# **ITS3 activities in Bari**

## **BBM6**

# BBM6\_ThermalTestAssembly\_03-04-2024.stp

BBM6\_ThermalTestAssembly\_16-02-2024.stp

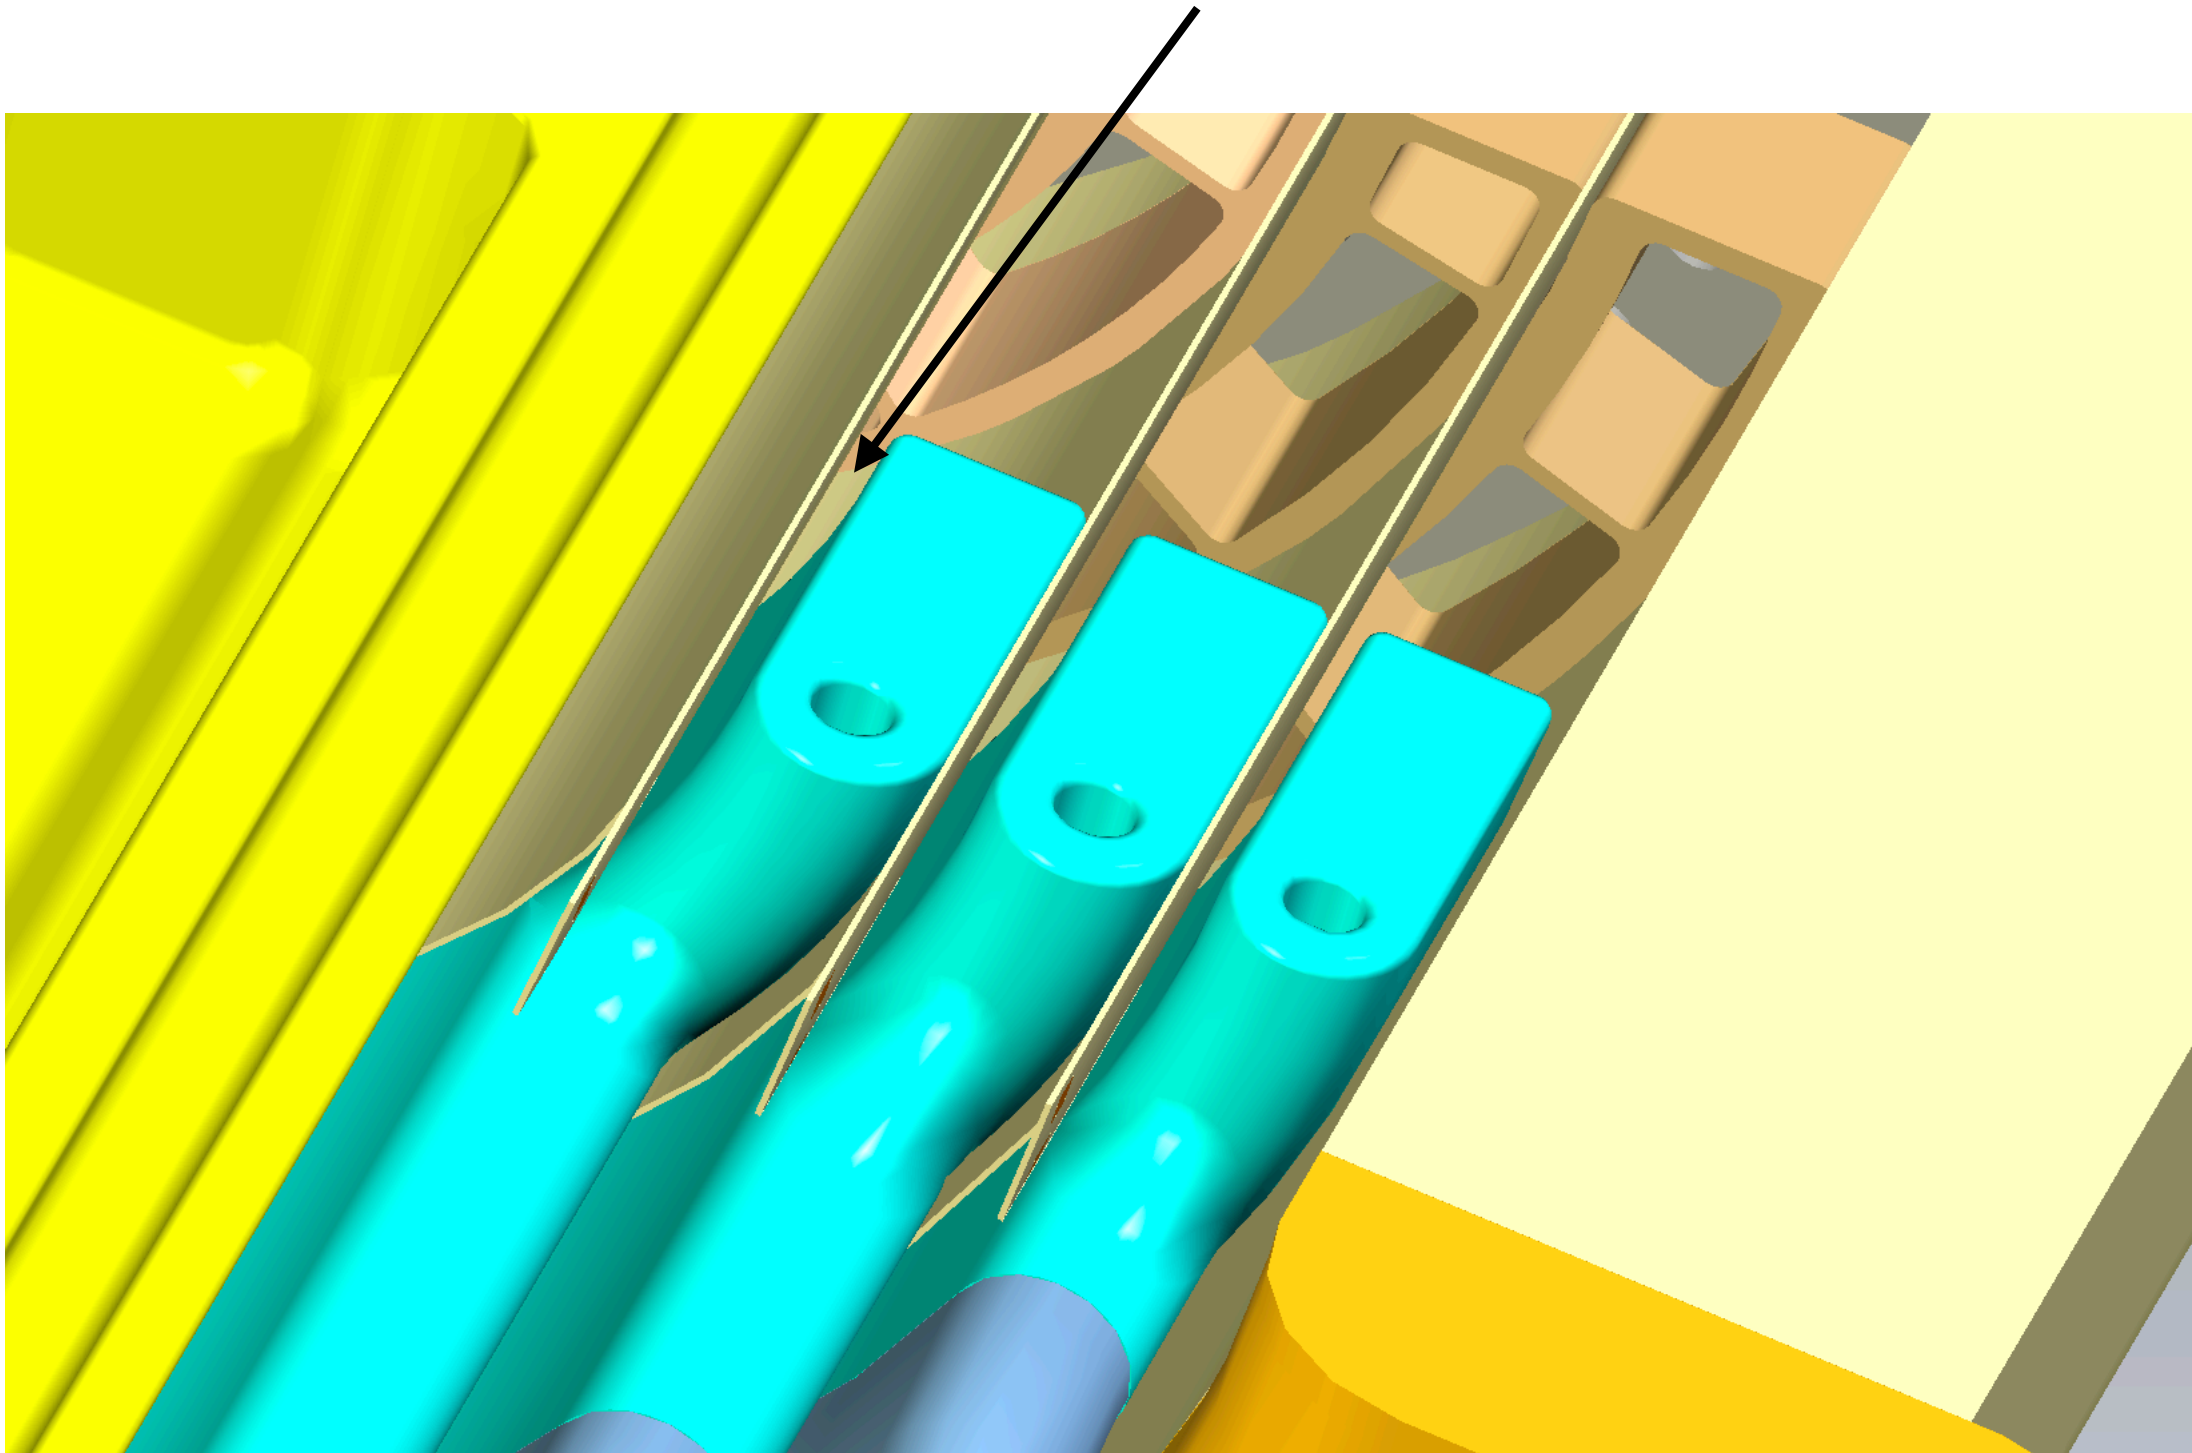
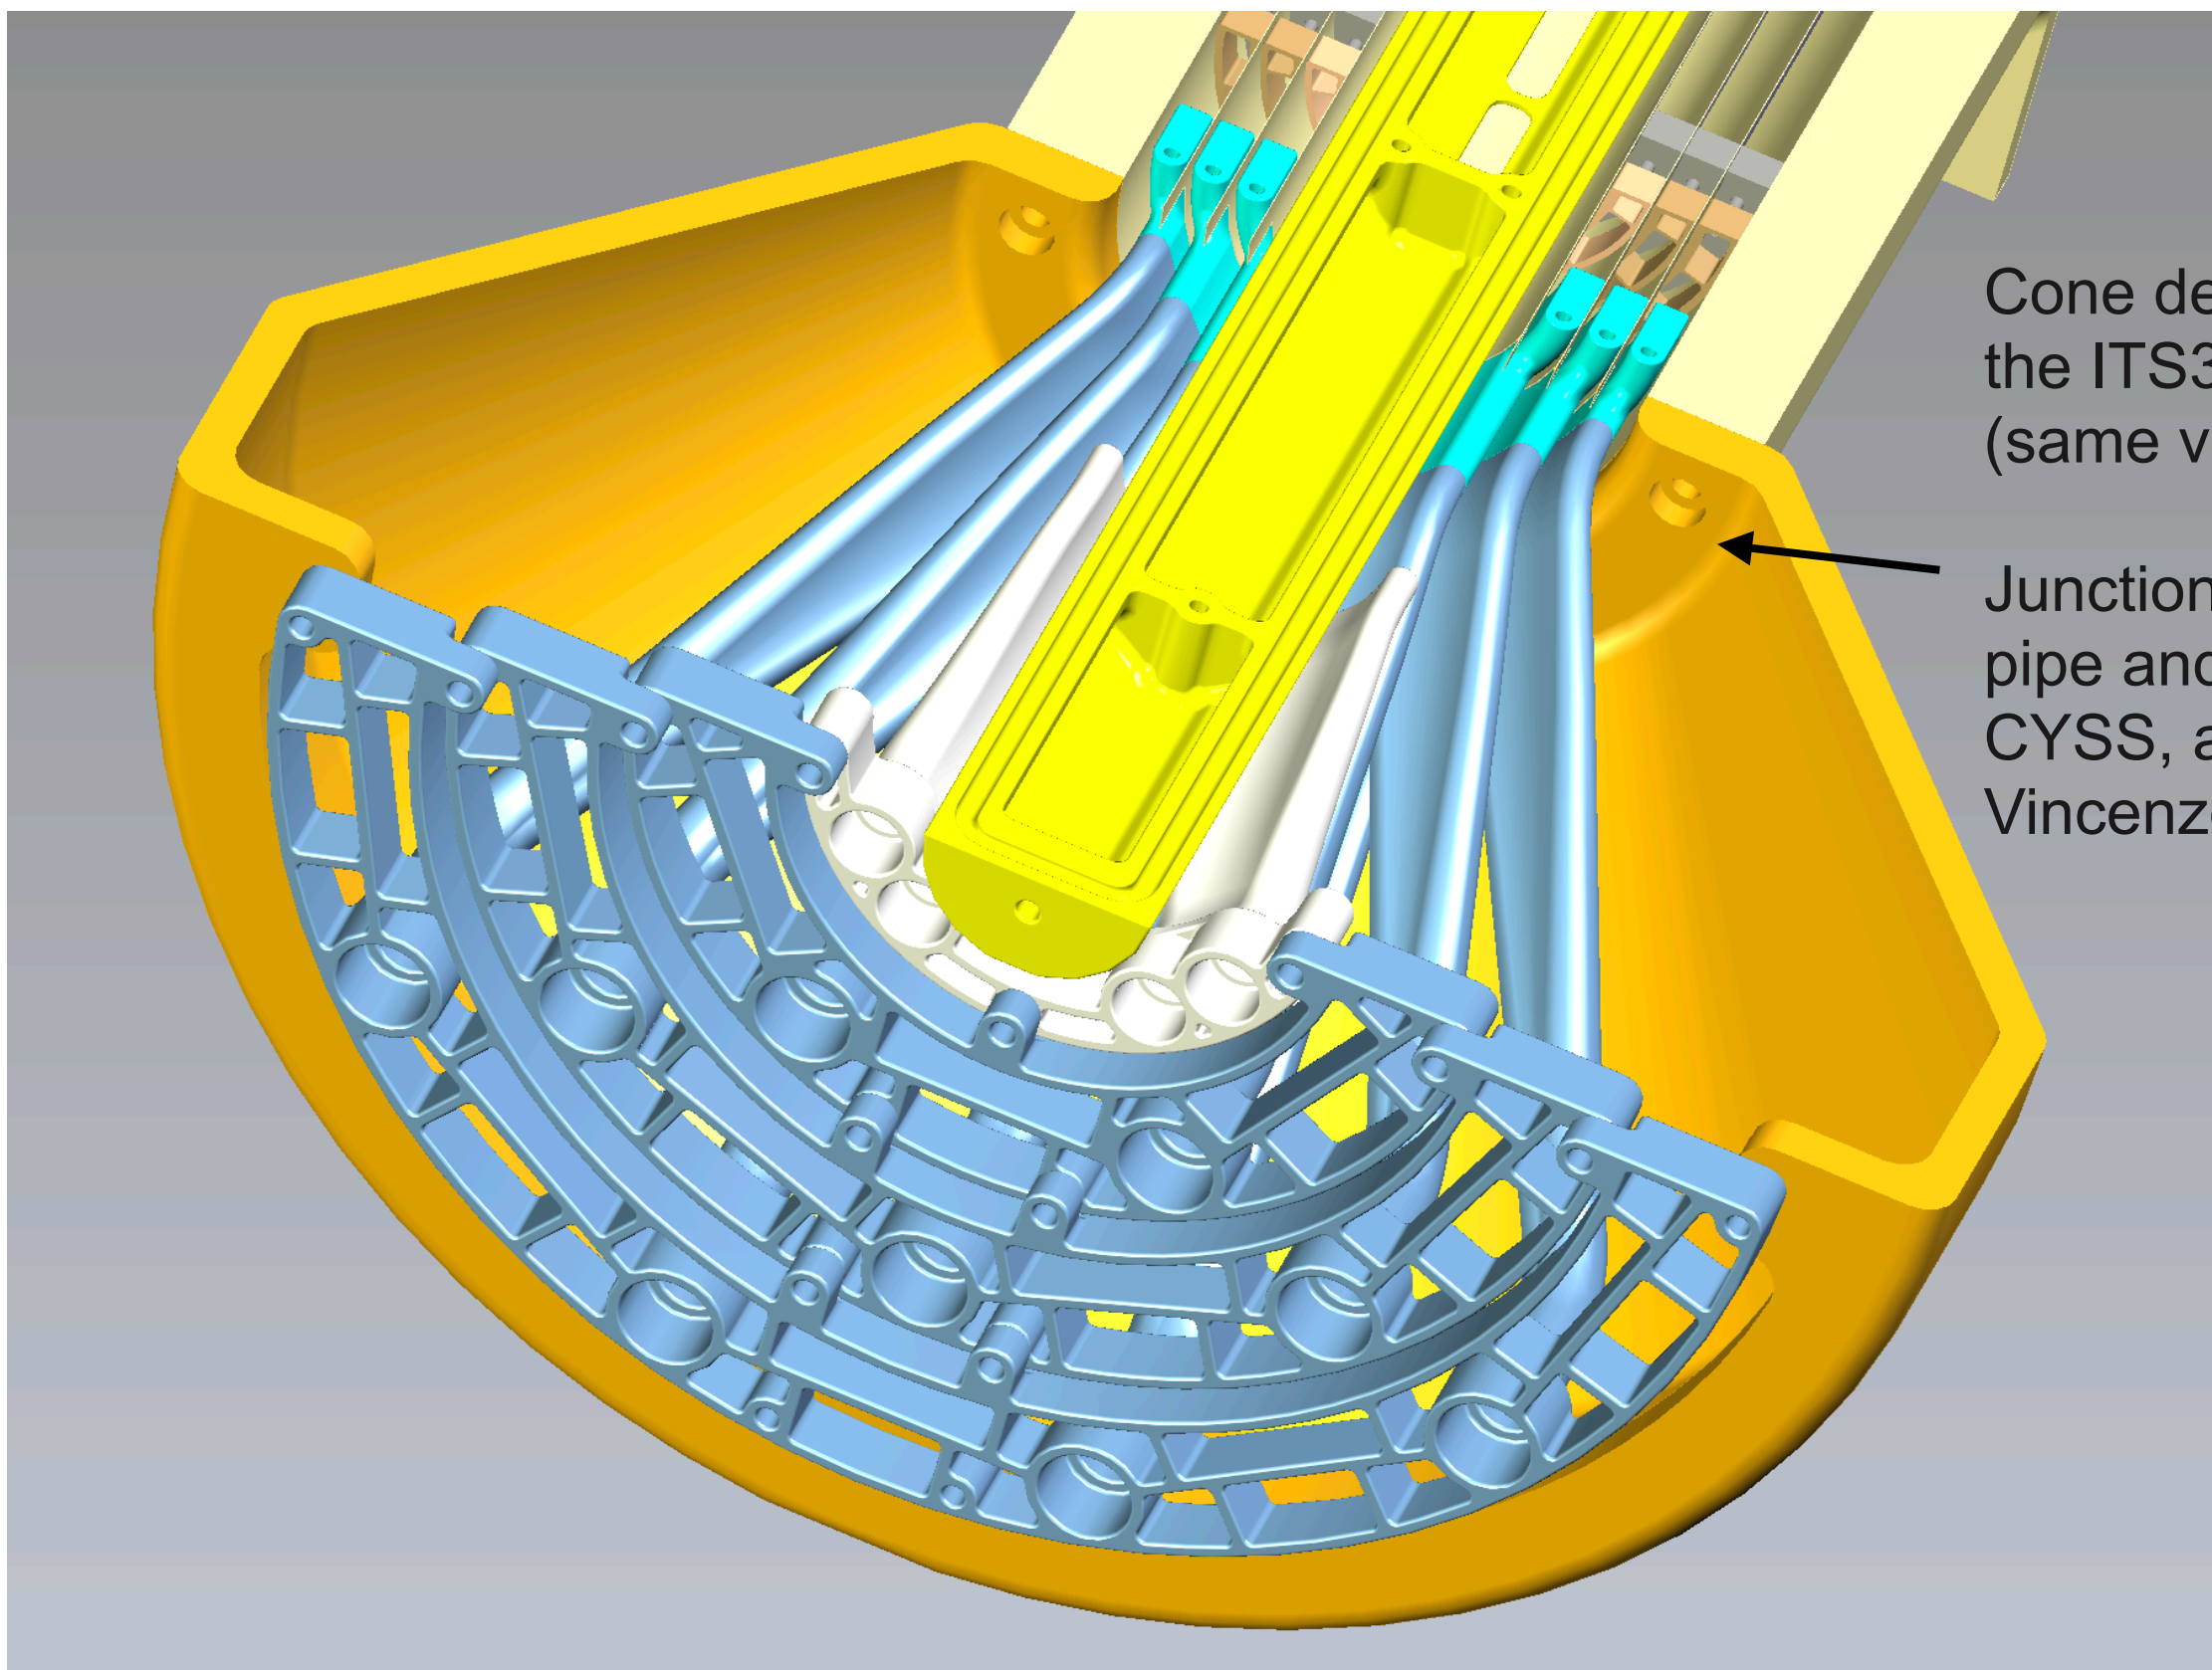
Changing layers radii and layers separation distance the cooling pipe thicknesses need to be adjusted

Cone design based on the ITS3 cone model (same volume).

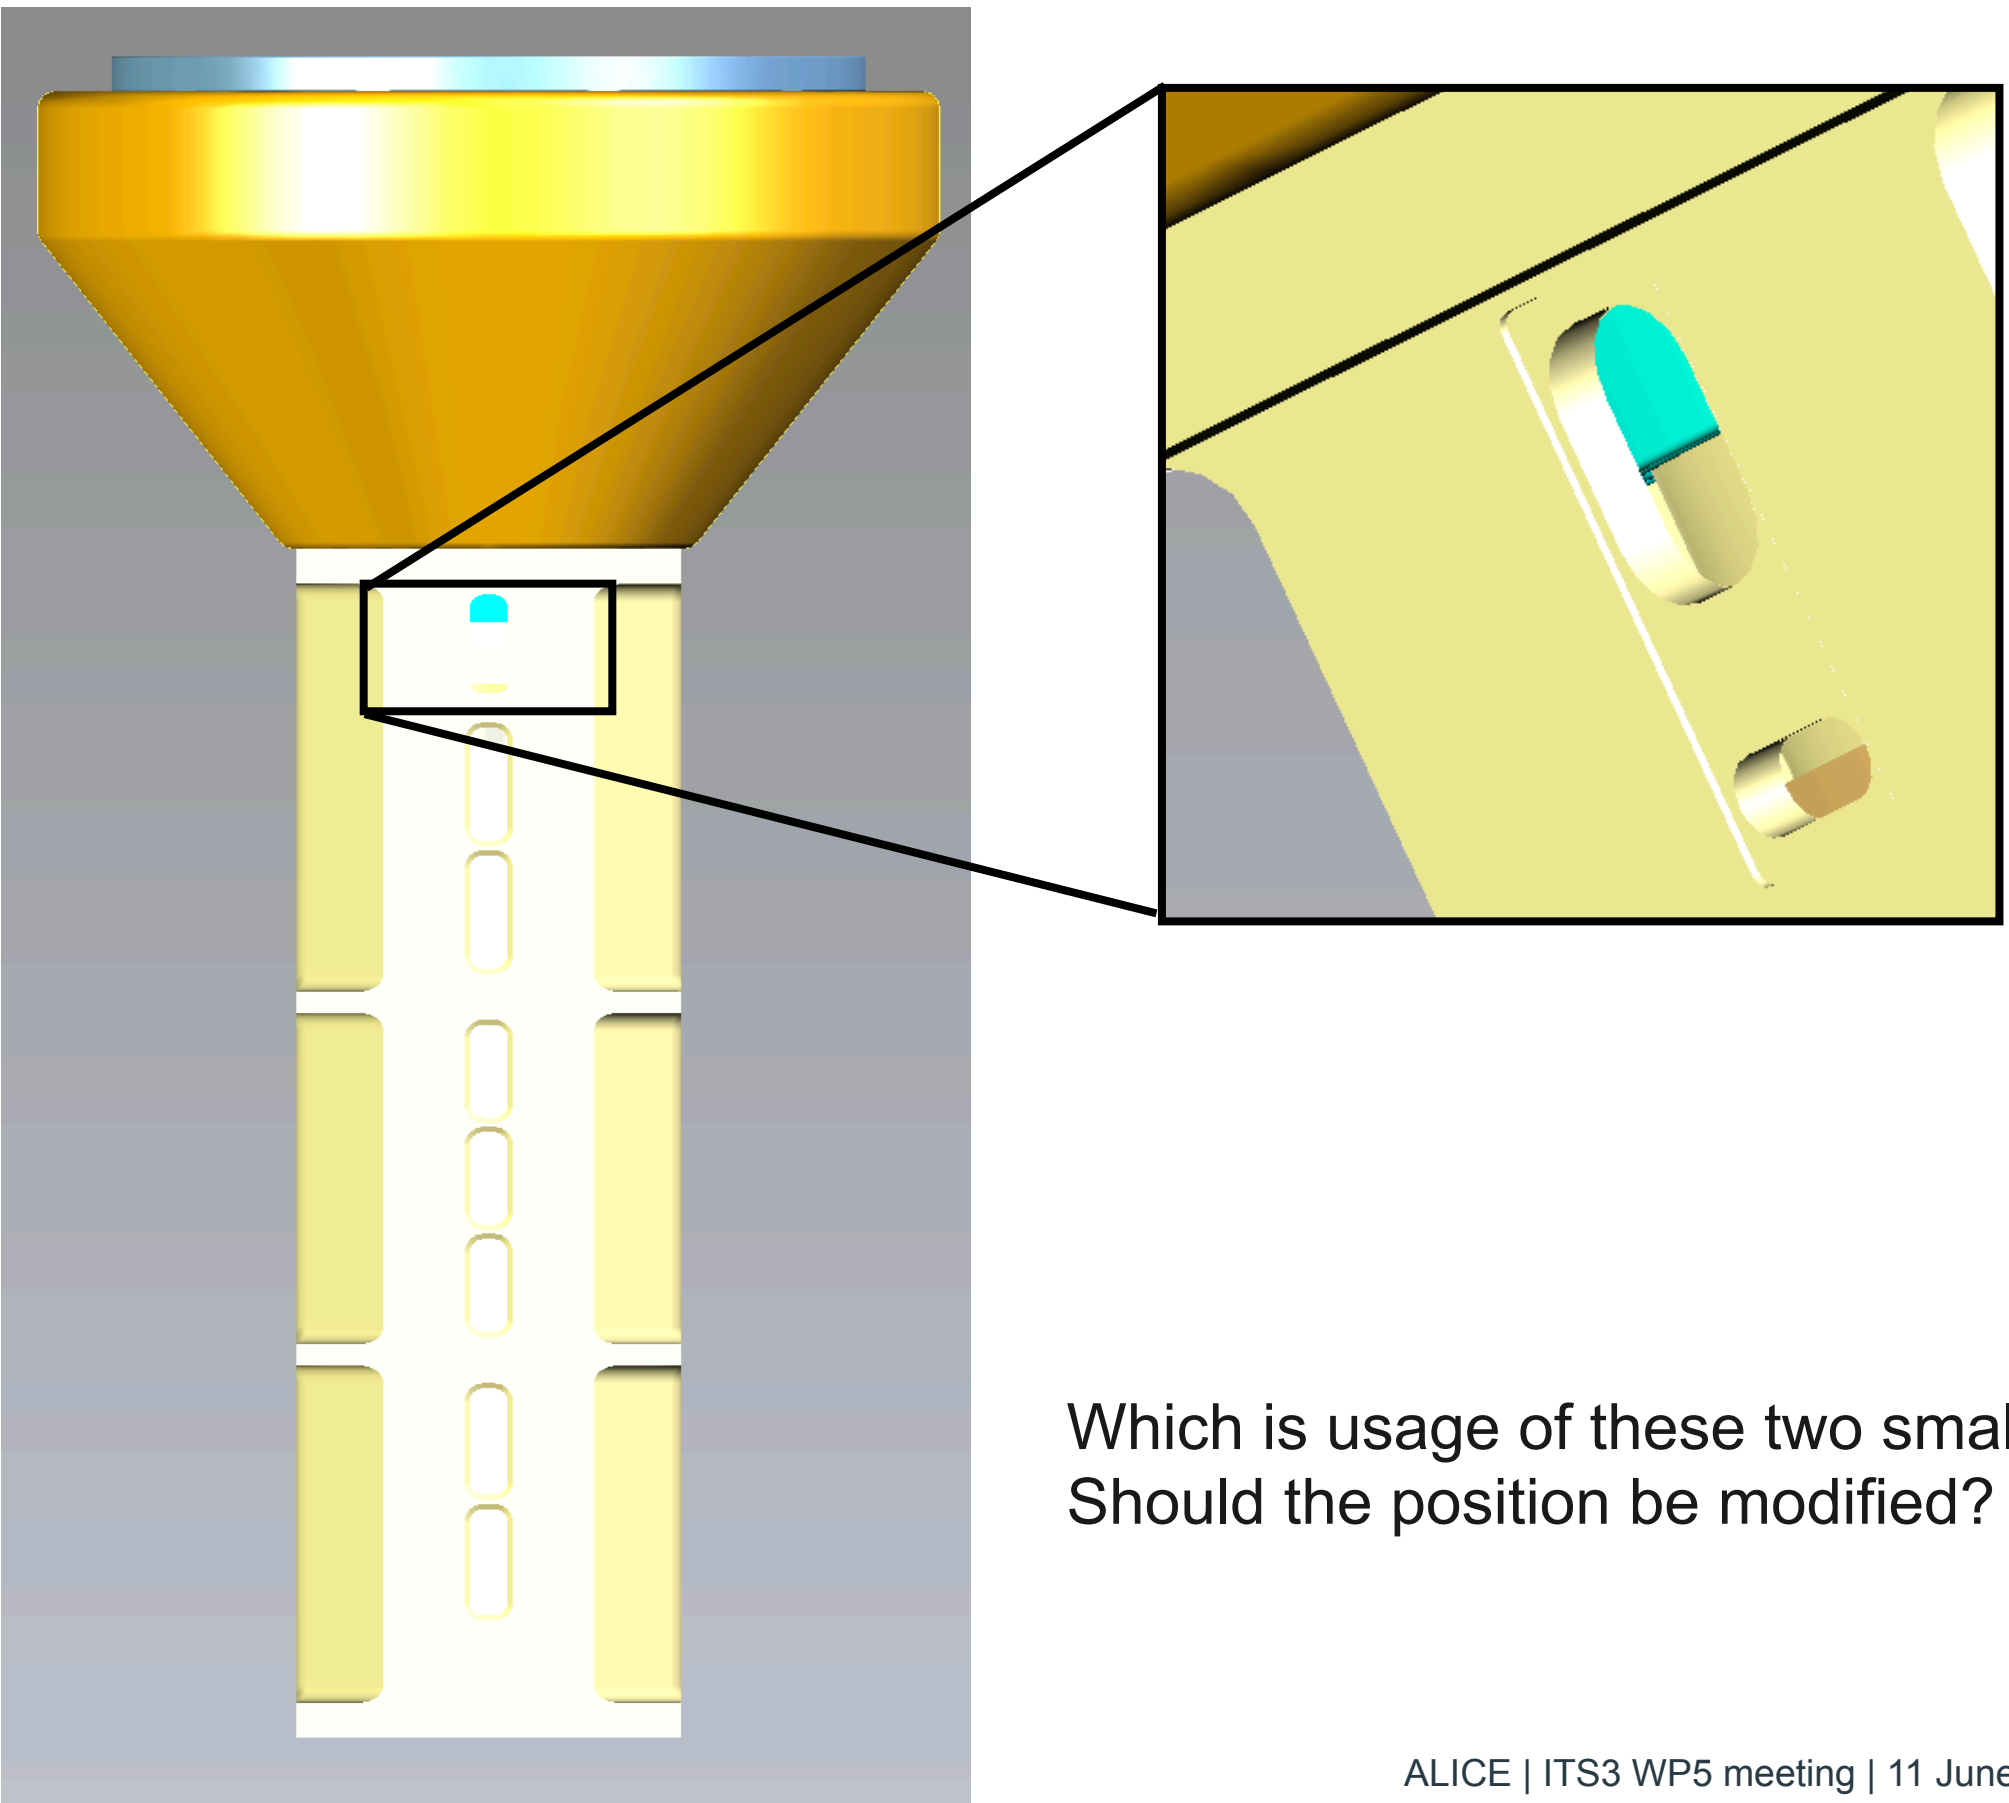
- Dimensions and positions of the big openings have been respected.
- Position of the first one interfere with the below half-ring.
- True also for the small window above interfering with service half-ring.
